ENCLOSURE 1

TENNESSEE VALLEY AUTHORITY  
SEQUOYAH NUCLEAR PLANT (SQN)  
UNIT 1  
DOCKET NO. 327

ADDITIONAL INFORMATION FOR TOPICAL REPORT NO. 24370-TR-C-002,  
"RIGGING AND HEAVY LOAD HANDLING"

Figure 1 – Steam Generator Haul Route

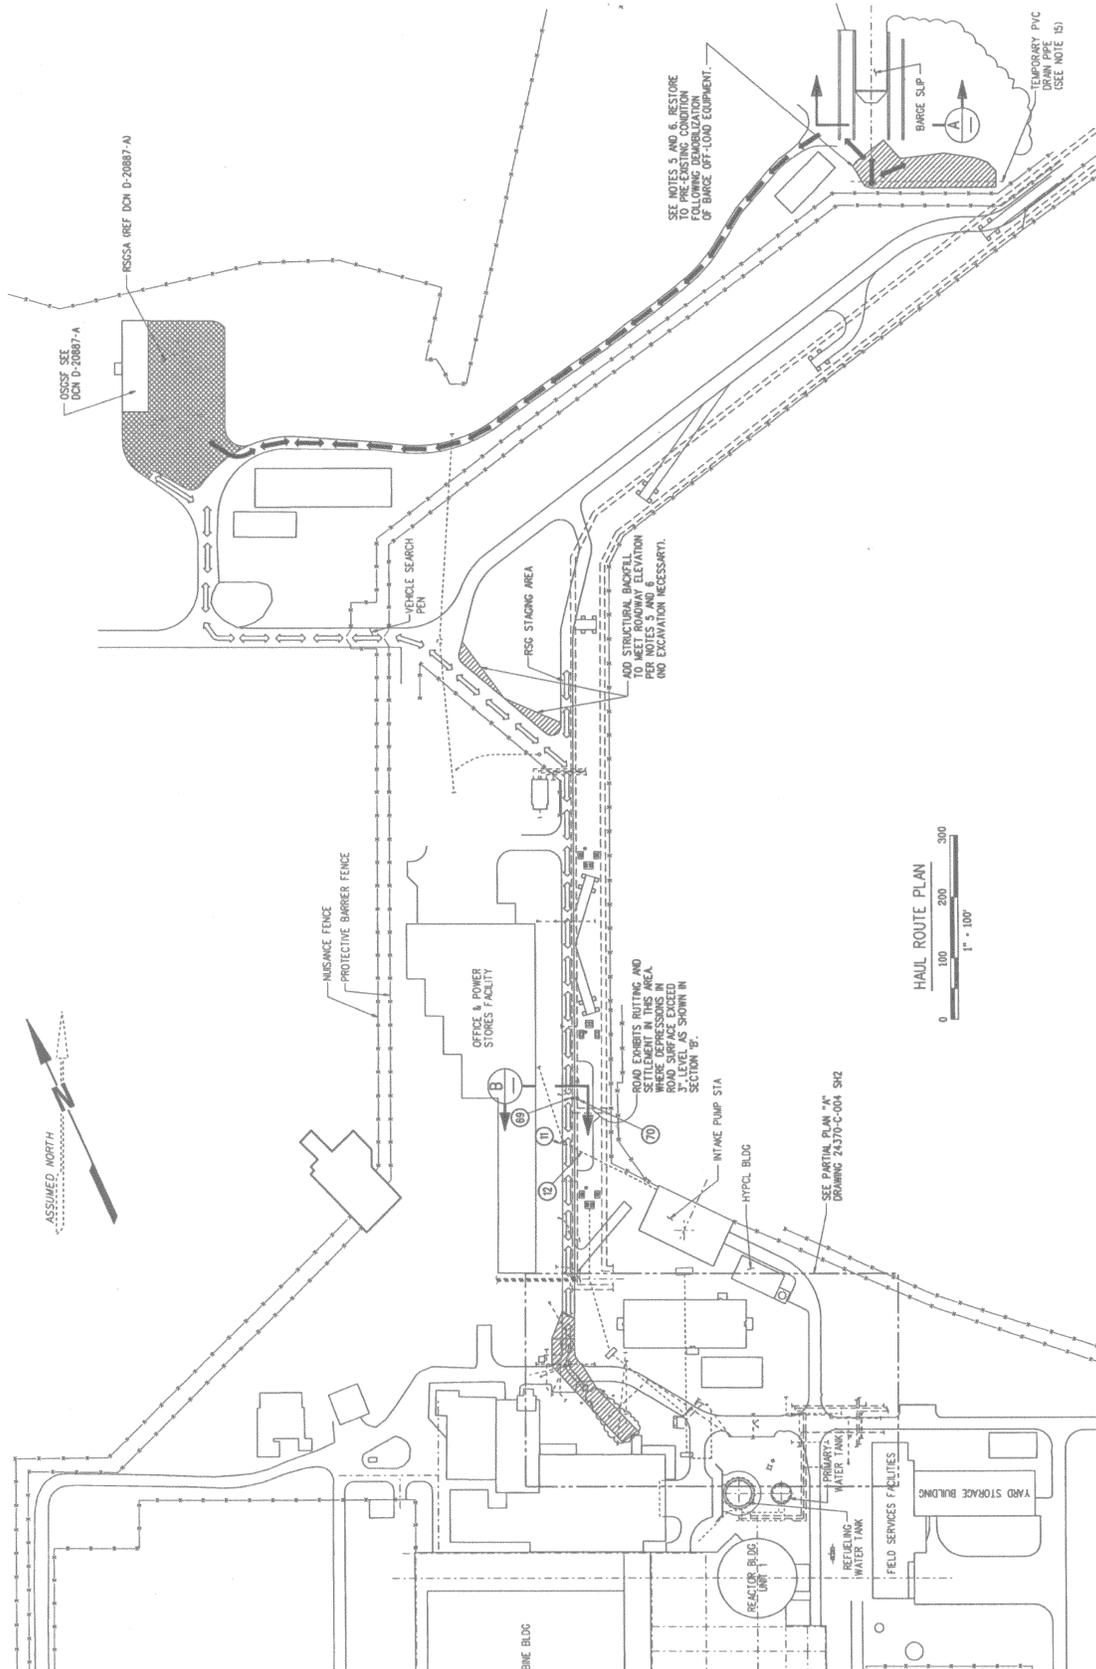
8. Section 7.1 of the topical report discusses the dose consequences of dropping an original steam generator (OSG) outside the containment. For staff to complete review of your dose consequences analysis, additional information is needed on the referenced calculation (Reference 23 of the topical). Provide the assumptions, inputs and methodologies used to determine the dose consequences of dropping the OSG. This should include the source term (isotopes and activities), control room ventilation system operation assumptions and the atmospheric dispersion factors (X/Qs) used in the dose calculation. Additionally, if the X/Qs are newly calculated and have not been reviewed by the staff, provide the inputs (including meteorological data), assumptions (including the location of the drop) and methodologies used to calculate the X/Q values.

20. The topical report provides no information on the haul route from the transport location identified on Figure 5-2 and whether the potential to interact with safety-related SSCs exists along the haul route, and whether those SSCs could either withstand the impact of a dropped SG or will be protected to preclude them from damage. What is the distance between the lay down area and the old and new SG storage area and what is the method used to load test the haul route (civil/structural)? What are the safety-related components that are located along the haul route that could be impacted by a dropped SG? What safety functions/systems would be impacted? What measures are to be taken to preclude a SG drop along the haul route and preclude the identified components from being damaged if a SG drop occurred?

The calculation performed to estimate worst-case atmospheric dispersion factors (X/Qs) at the EAB and at the LPZ for a hypothetical steam generator drop accident occurring at any point along the steam generator haul route [Figure 1] during the SGR is summarized below.

3. The containment building cross-sectional area (1800 m<sup>2</sup>) used in estimating the atmospheric dispersion factors were as reported in UFSAR Section 2.3.5.2.
4. A haul route drawing [Figure 1] shows the locations of the steam generator haul route and the old steam generator storage facility (OSGSF).
5. The elevation at the top of the containment building is 856.04 ft with a grade elevation of 705 ft. Therefore, the physical height above ground level of the containment building is 151 ft (46 m).

The SG haul route is shown on Figure 1 in the response to Question 8. The distance from the downending/upending (lay down) area to the OSGSF-replacement steam generator storage area (RSGSA) is approximately 2,180 ft. A review of SSCs in the vicinity of this portion of the haul route determined that the only safety-related SSCs are the ERCW ductbanks, manhole (MH) groups 31 and 32, handhole (HH) group 52, and 36 inch diameter ERCW piping. The MH and HH groups are associated with the ERCW ductbanks. There are no safety-related utilities close enough to the portion of the haul route between the replacement steam generator (RSG) barge offload area and the RSGSA to be affected by a load drop.

Figure 5-2 – Outside Lift System Location

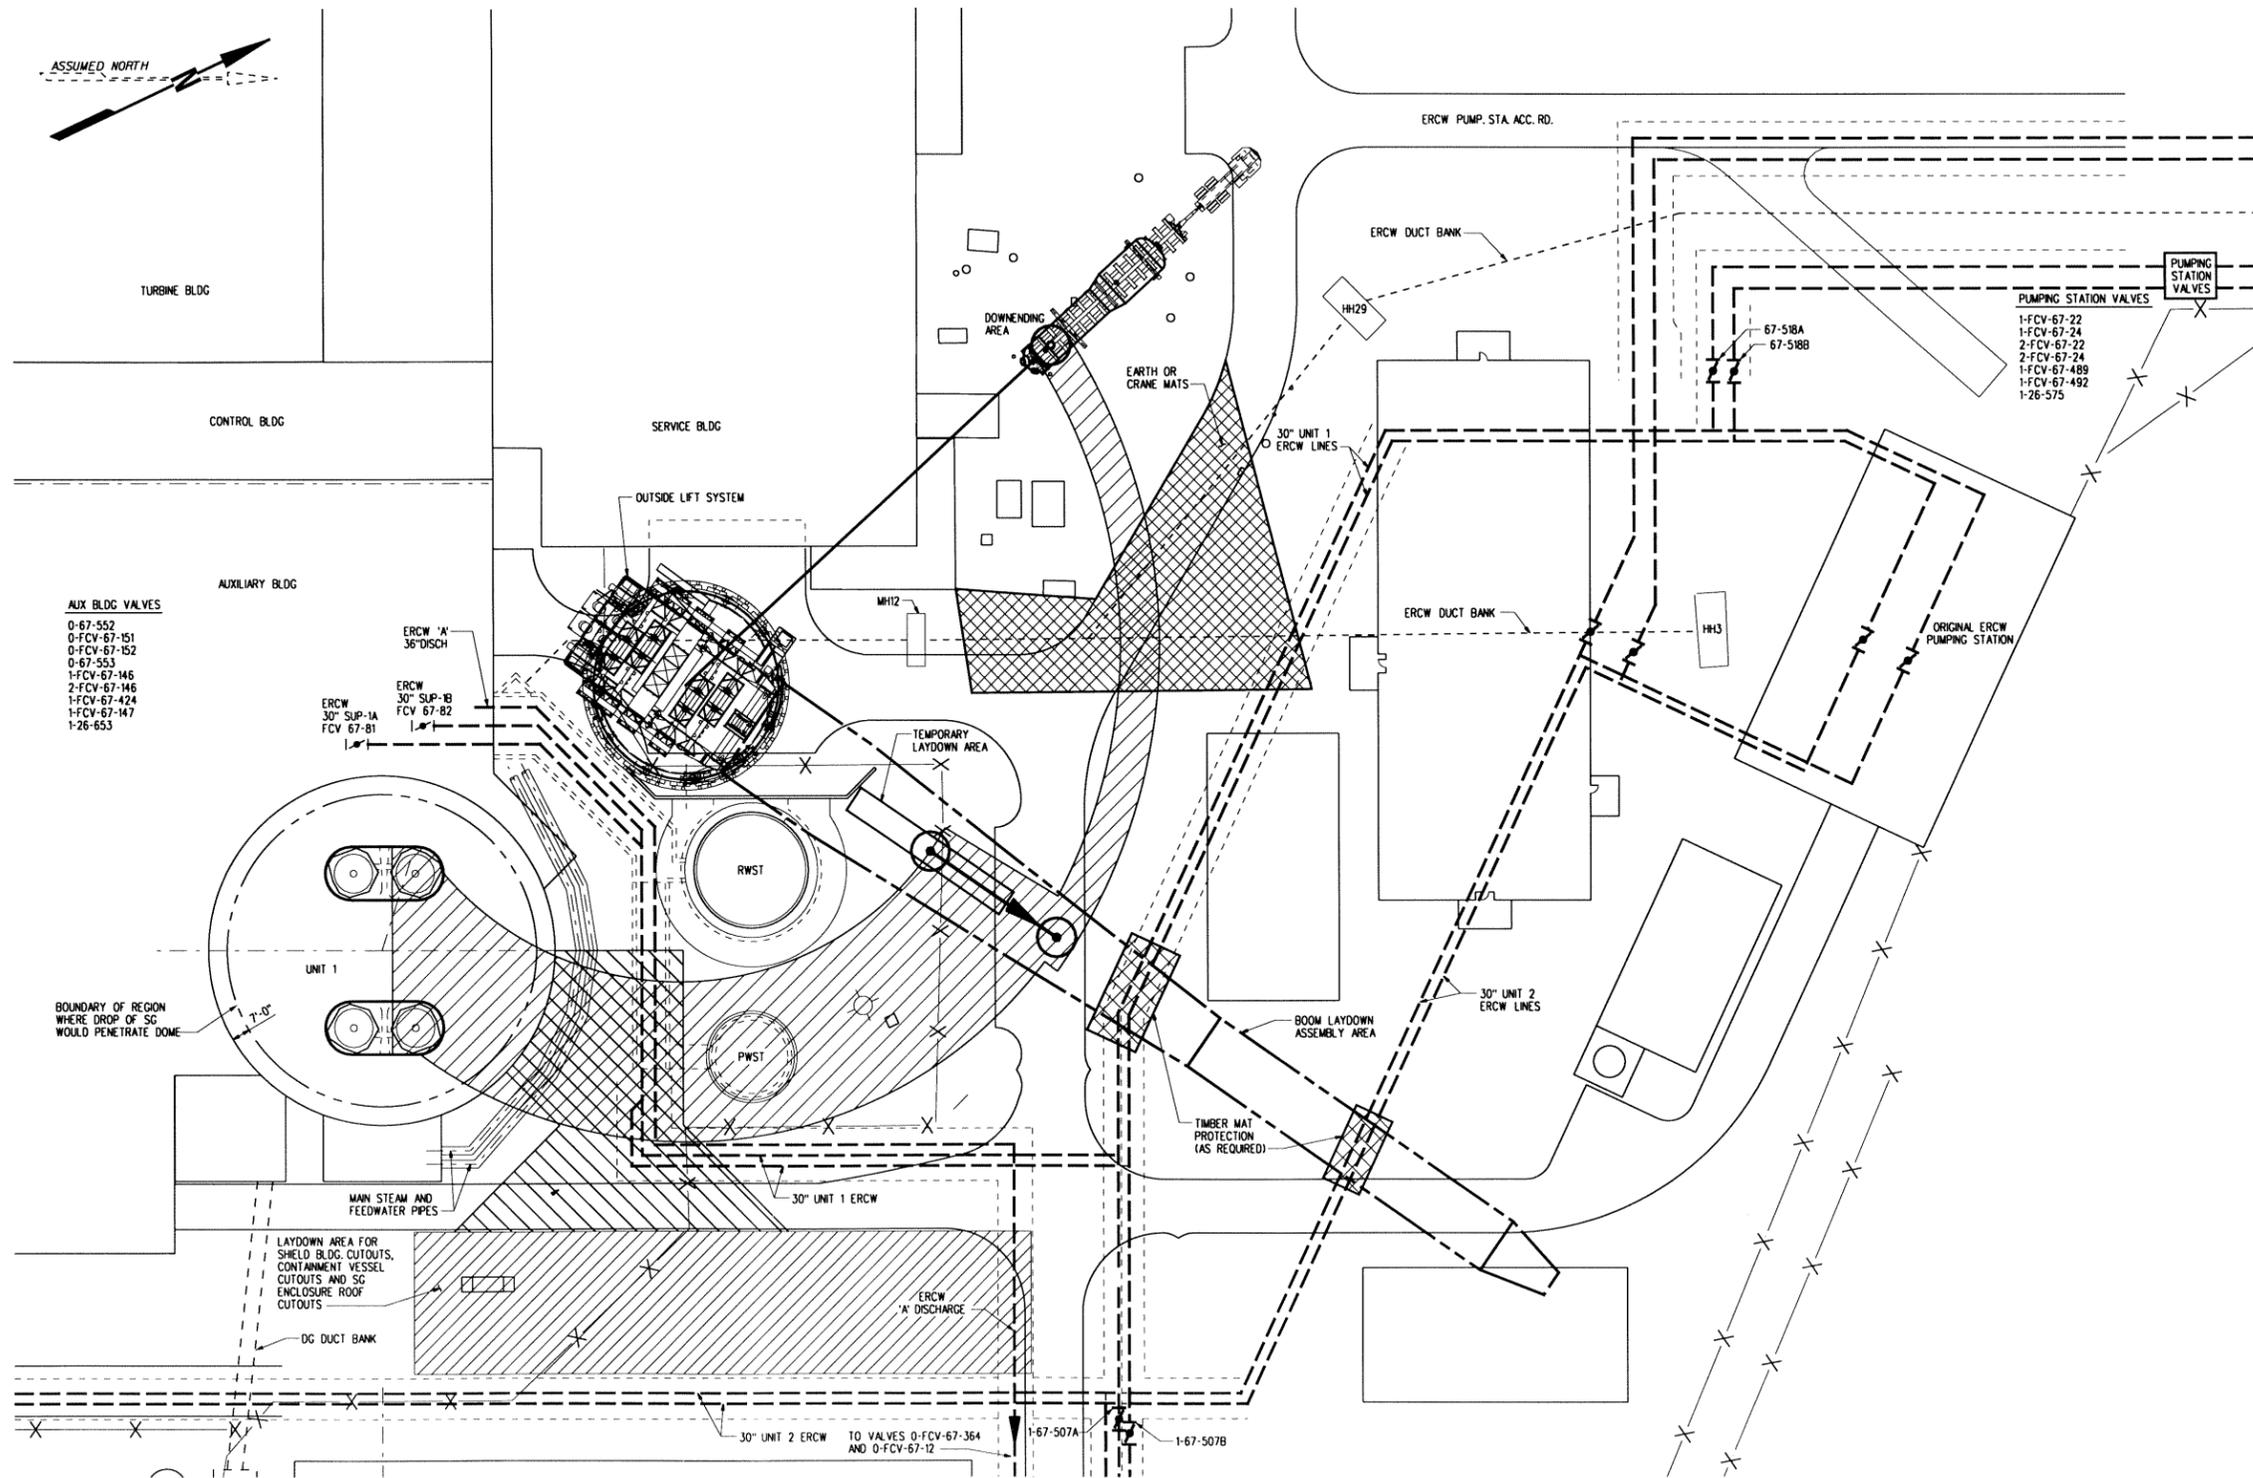
17. Section 5.2 of the submittal states that "restrictions on the use of these cranes (mobile cranes-lattice boom and/or truck) will be imposed to specify the weather conditions under which they may be operated and how and when to secure the mobile cranes in case of inclement weather; and the restrictions are designed to preclude adverse interactions with safety-related SSCs [systems, structures and components]." With respect to the use of the mobile cranes for assembly and disassembly of the OLS, provide a response to the following:

26. Although safe load paths have been identified on Figure 5-2 of the rigging and heavy load handling topical report the staff believes that it will be difficult for the operator to stay within the safe load path during the various lifts. Describe the communications plan, administrative controls, crane operator actions, and crane automatic actions used to control the lift within the safe load path identified in figure 5-2 of the topical report.

- (1) Load handling with the mobile cranes is limited to an approved area around the OLS boom location shown on Figure 5-2 of Topical Report 24370-TR-C-002.
- (2) The load imposed on the ground by the crane is limited to the calculated allowable ground bearing pressure of 4 ksf.
- (3) Timber mats will be placed as shown on Figure 5-2 in Topical Report 24370-TR-C-002 over safety-related utilities (ERCW pipes).
- (4) Loads traveling over safety-related systems, structures and components (SSCs) shall be carried as low to grade as possible. Loads up to 50 kips may be lifted up to 20 ft above safety-related SSCs as long as the safety-related SSCs are protected with 1 ft of timber mat.

The approved area around the OLS boom location shown on Figure 5-2 of Topical Report 24370-TR-C-002 is a safe load path as long as the cranes are operated in accordance with the restrictions listed in 17.(a) and 17.(b) above and the protection listed in 17.(f) below is in place.

Protection (see Sections 7.5 and Figure 5-2 of Topical Report 24370-TR-C-002) for safety-related SSCs has been designed and will be used. With this protection in place, safety-related SSCs will not be affected by a load drop from or overturning of a mobile crane.

Since it is difficult to predict where the SG will go following an impact from an arbitrary height onto the dome, an analysis was performed to determine the minimum height above the dome a SG would need to be suspended to guarantee that it would penetrate the shield building. This minimum distance between the SG and the shield building dome will be maintained by lifting the SGs vertically through the containment openings until the defined minimum clearance is attained. The SGs will then be translated horizontally to the outer edge of the containment as shown on Figure 5-2 of Topical Report 24370-TR-C-002.

The ERCW ductbanks that are the subject of this question are: (1) Ductbank between manhole MH12 and handhole HH3 (called ductbank DB1); and (2) Ductbank between manhole MH12 and handhole HH29 (called ductbank DB2). See Figure 5-2 of Topical Report 24370-TR-C-002 for location of the ductbanks. They are both well over 200 ft in length. The critical postulated impact was from a flop-over fall after the SG has been dropped from the OLS, the load being carried at a height of 3 ft above grade along the load path at or near the ductbank locations. From TVA drawing 10N251, the grade above the ductbanks in the fall zone of a dropped generator varies from 704 ft to 707 ft. Based on the subsurface investigation performed for the SGR, the soil around the ductbanks is clay fill. The soil properties used in the evaluation were based on the above subsurface investigation and from the UFSAR.

This will require areas above the ductbank, within the fall zone, with grade elevation below 707 ft to be raised to 707 ft using any earthfill placed in a standard way. The areas where fill may be required are shown as the cross-hatched area on Figure 5-2 of Topical Report 24370-TR-C-002. The depth of fill required will vary from 0 ft to 2.5 ft. Since this is a protection for impact loading and a reasonable moment margin being available, there are no specific compaction requirements, because the energy will be dissipated by displacing the soil even if it is not well

be in constant radio communication with the crane operators and load tenders inside containment. A field engineer will be with the PIC who will be in constant communication with the operator in the control room. Figure 5-2 presented in Topical Report 24370-TR-C-002 is only a schematic designed to illustrate the load path in a general way. The actual implementation drawing precisely defines each segment of the load path.
